Coffs Harbour Bypass

Amendment Report

Volume 1A. Executive summary, Chapters 1-4

Coffs Harbour Bypass
Russ Hammond Close connection
Figure 3-2

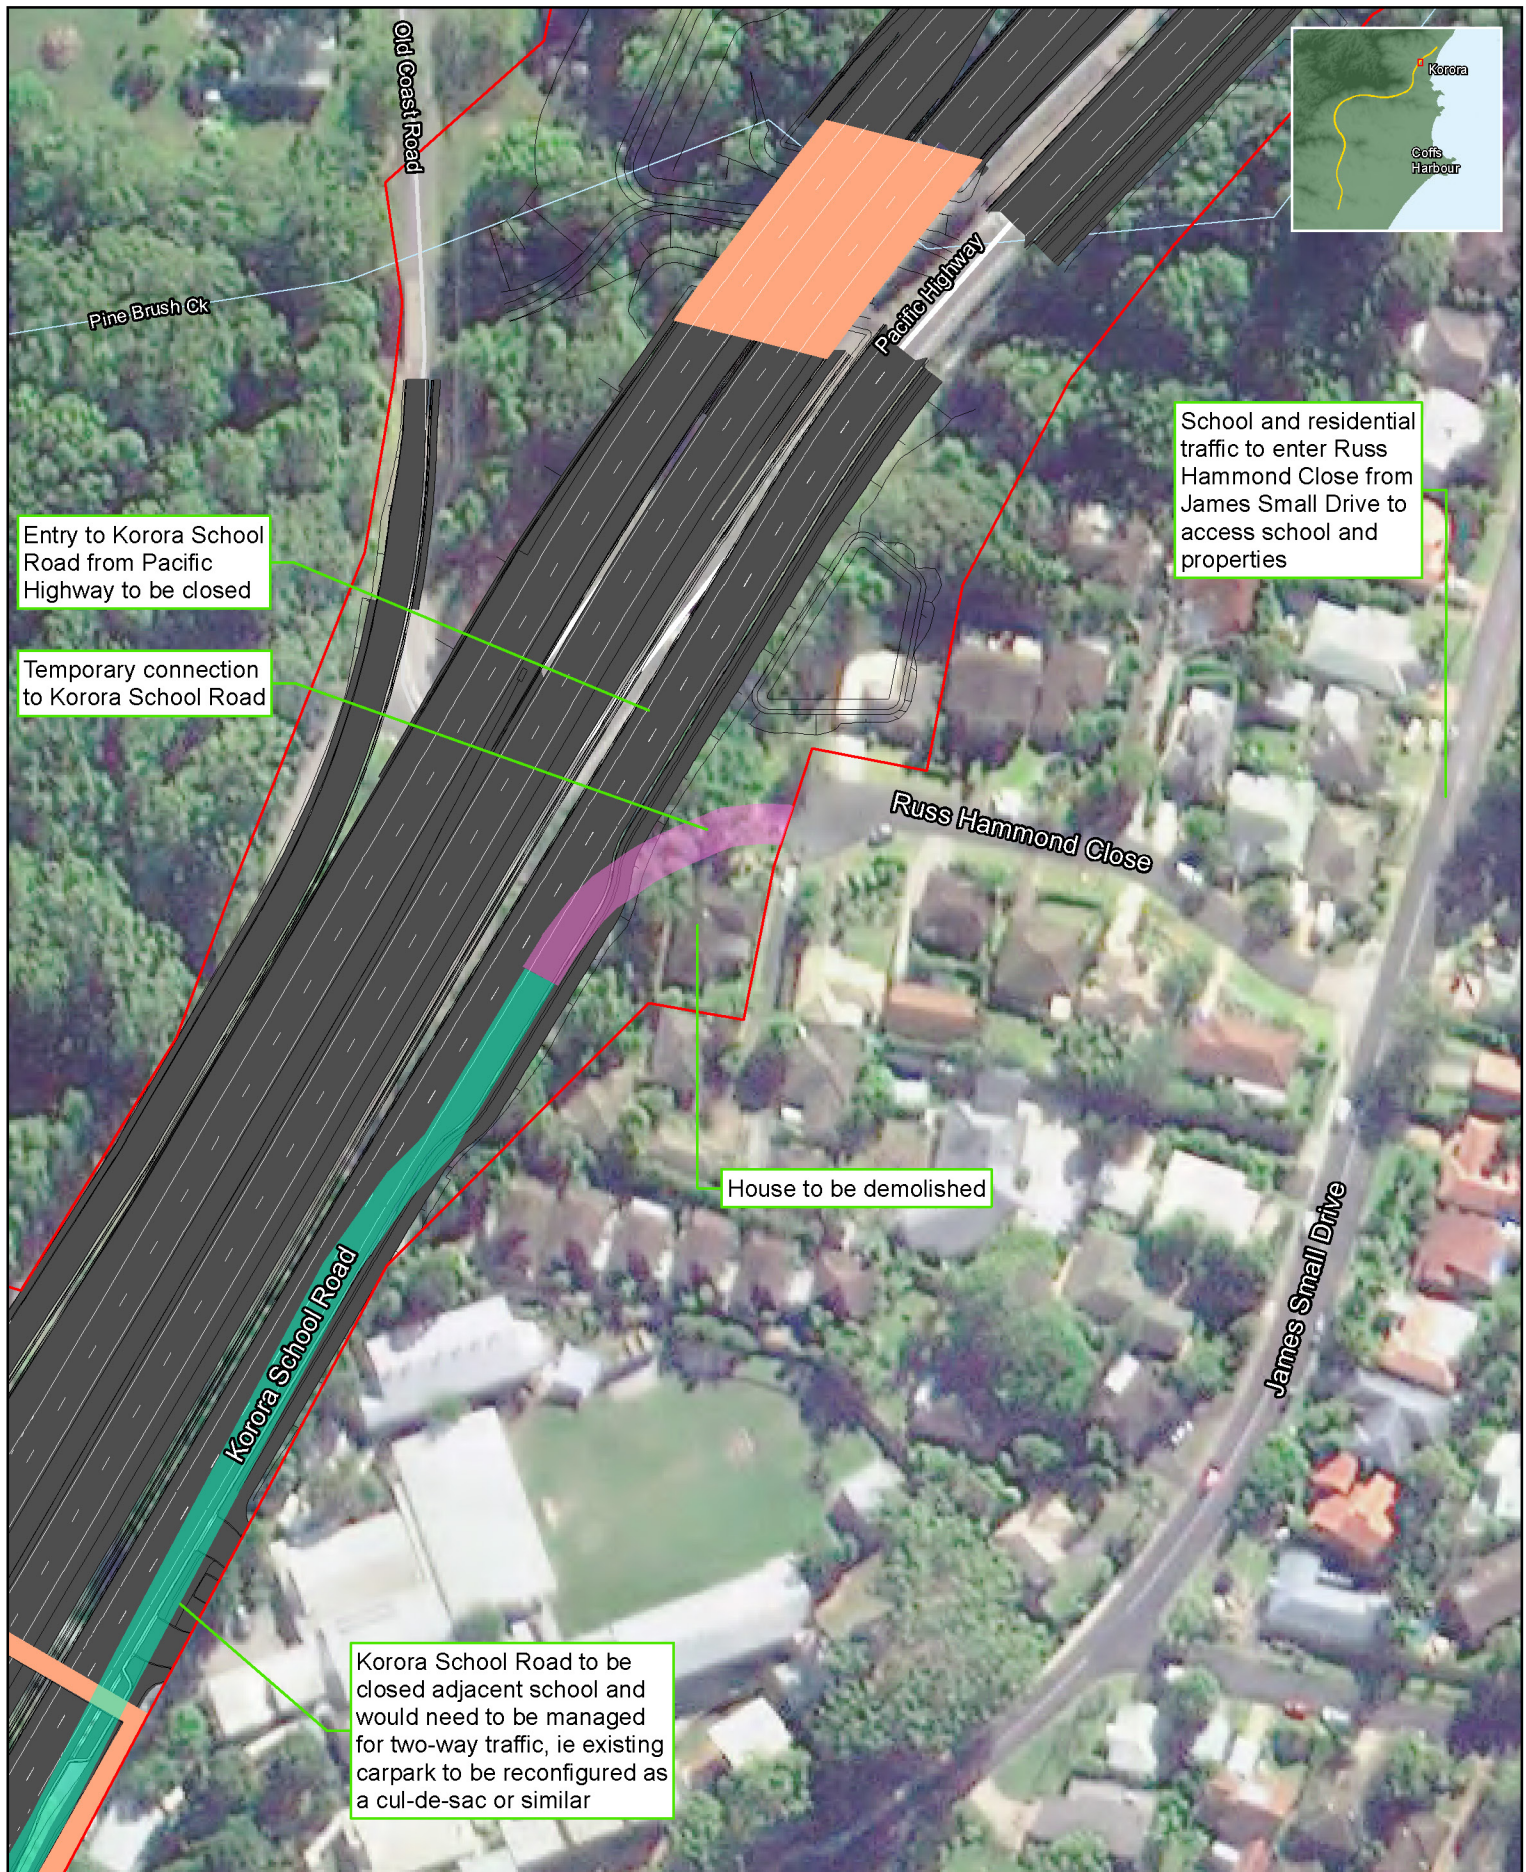
Two new construction access roads would be needed for the project. These new construction access roads are Buchanans Road and Gatelys Road. Russ Hammond Close would be required for temporary local access during construction. The new construction access roads and the temporary local access road are shown in **Figure 3-1-01** to **Figure 3-1-06** and the Russ Hammond Close connection is shown on **Figure 3-2**.

During construction, access to Korora School Road from the existing Pacific Highway would need to be closed and a temporary connection required to maintain access to Kororo Public School and existing residential properties on Korora School Road. The temporary access is proposed via Russ Hammond Close and would involve providing a connection between the cul-de-sac to Korora School Road through TfNSW owned property.
